This is a new DP for an I-2 project on the east side of Clark and a few blocks north of E 1st Ave. Cody (PC) is sorting out some issues with the applicant, but I suspect drawings are being distributed. Could you please assign to one of the Metro Core planners? I'll be sure to pass on the drawings if I get them, and any info from the enquiry.

1290 CLARK DR

2 HYDRO WEST
1/16" = 1'-0"

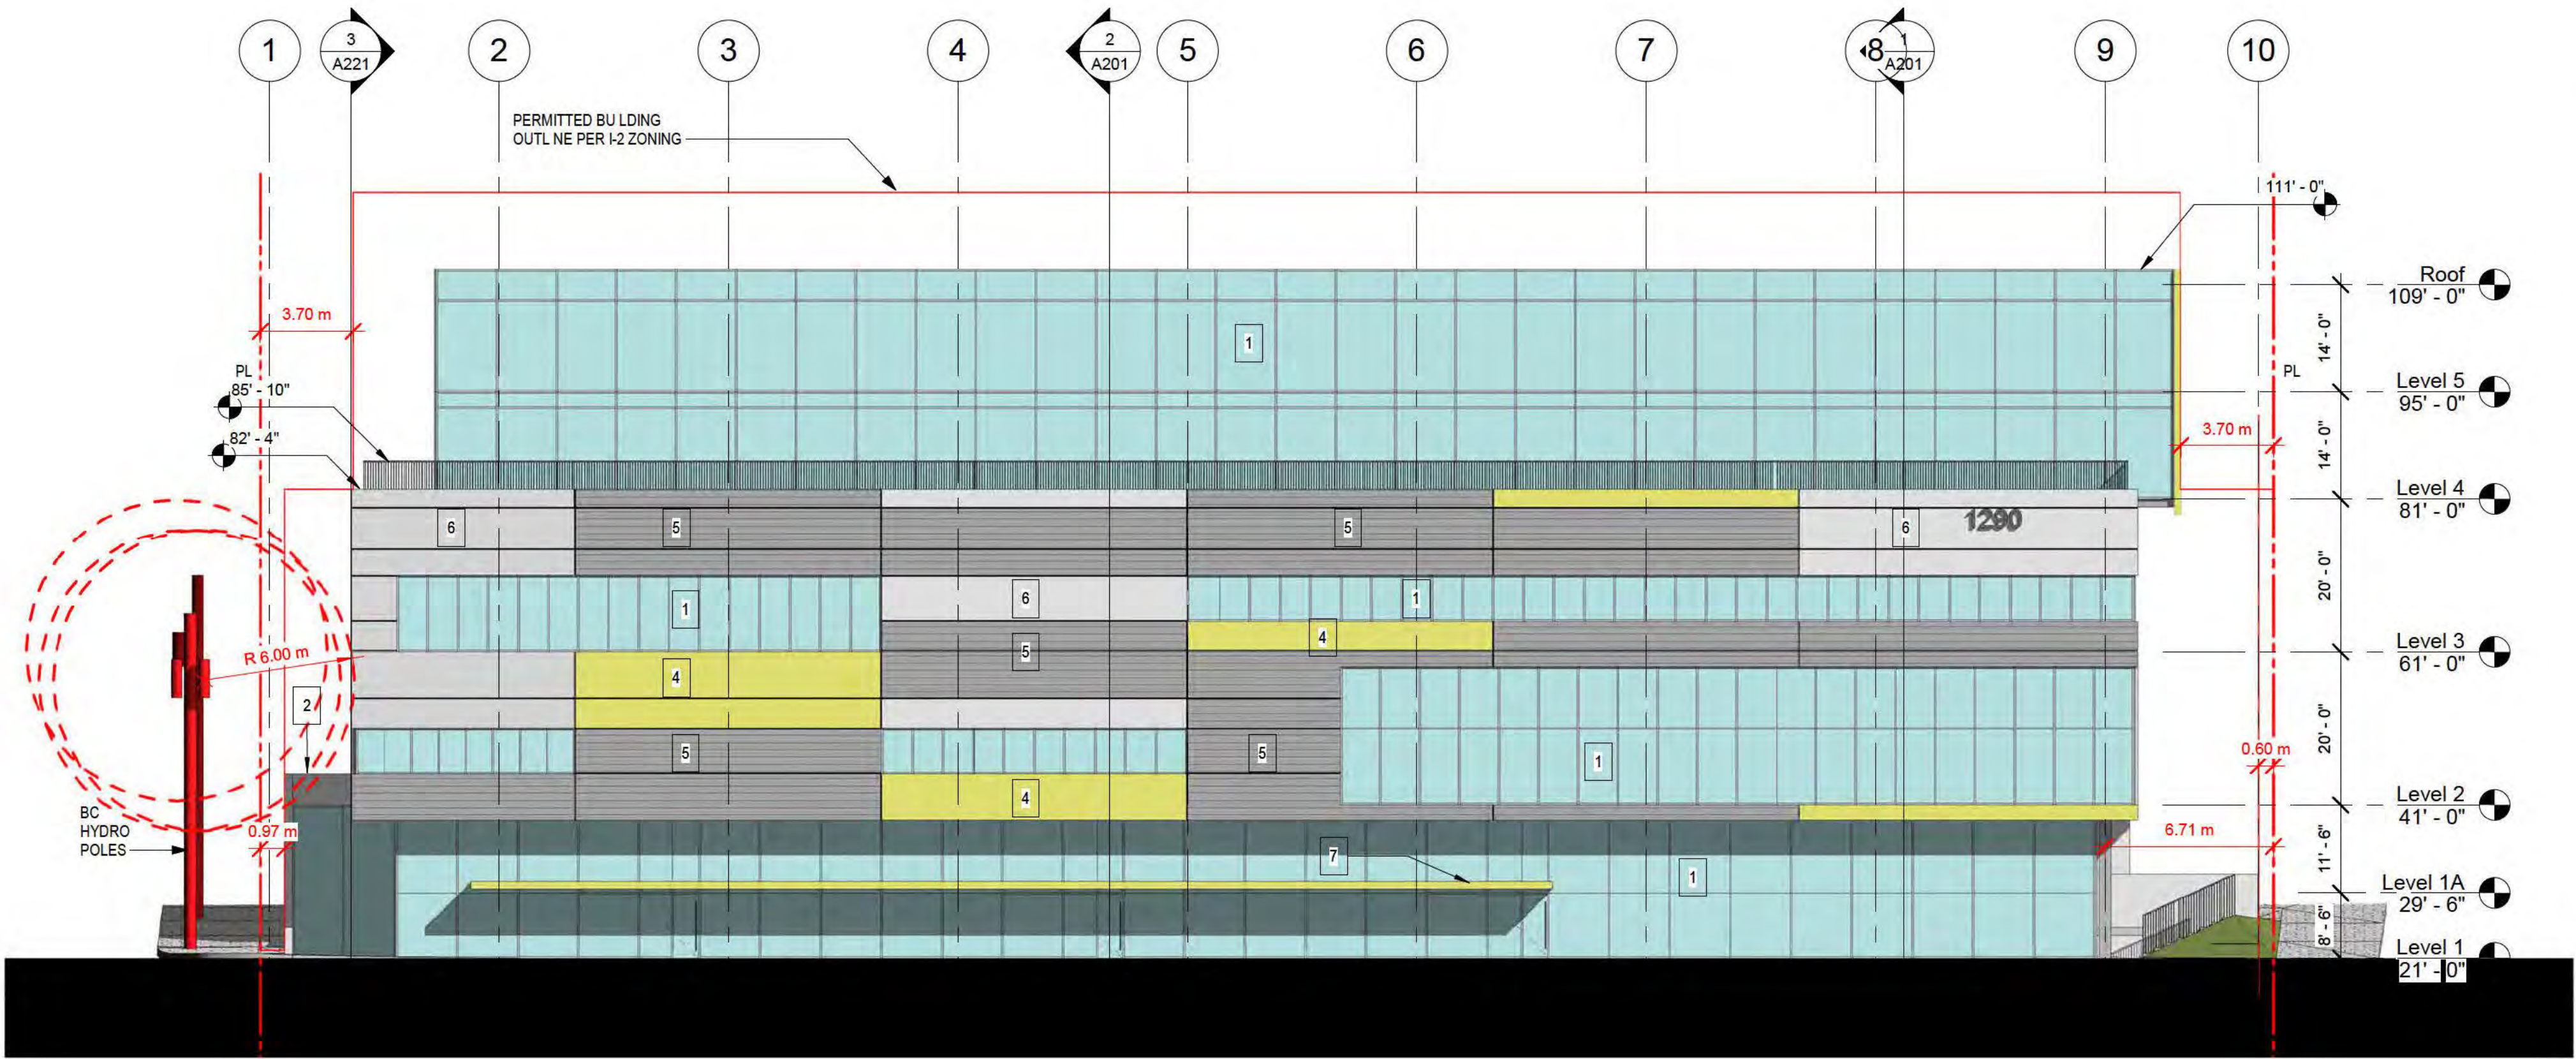
- NE site corner – pole is shown on plans, but survey not showing transformer
- NW site corner – triple transformer on single pole on survey, concern with proximity to building?

- HC Hydro Clearance Form not received, and noted that **existing poles/transformers not clearly noted or designed for clearance on plans**
 - NW site corner – triple transformer on single pole on survey, concern with proximity to building?
 - NE site corner – pole is shown on plans, but survey not showing transformer (not matching streetview?)

- HC Hydro Clearance Form noting clearance is met but proposing a balcony beneath the 6m sphere, and also see supplementary information requested showing existing poles/transformers to be clearly added to drawings with PTR revision with notes clearly explaining proposed condition:
- NW site corner – triple transformer on single pole on survey, concern with proximity to building?
- NE site corner – pole is shown on plans, but survey not showing transformer (not matching streetview?)

As per our discussions I will make amendments to the site plan and will include the correct survey as requested.
